# Rezoning Transportation Analysis

Petition Number: 2017-006

General Location Identifier: 02964110

## Curbline

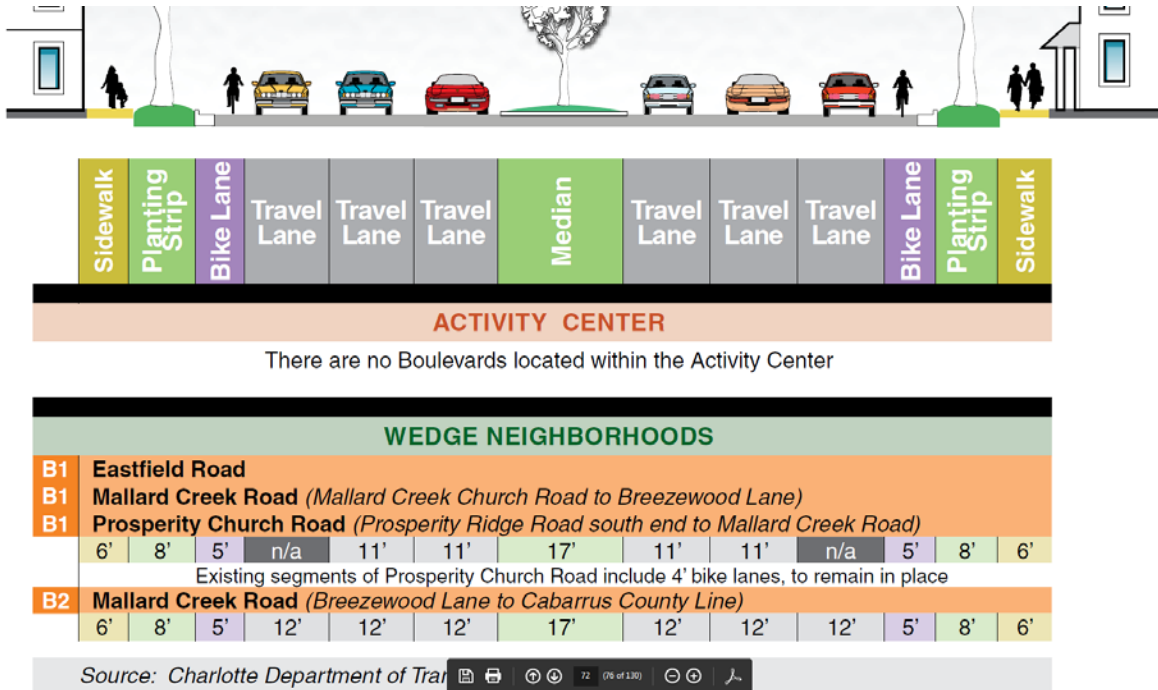
- Eastfield Rd.'s proposed back of curb line needs to be located 38' as measured from its existing centerline to accommodate the Boulevard section defined in the area plan (see below). This does not include width that may be needed for turn lane(s). An additional 3' of widening may be needed for a 3' buffer for the bike lane.
- Highland Creek Pkwy's existing curbline can remain as is.
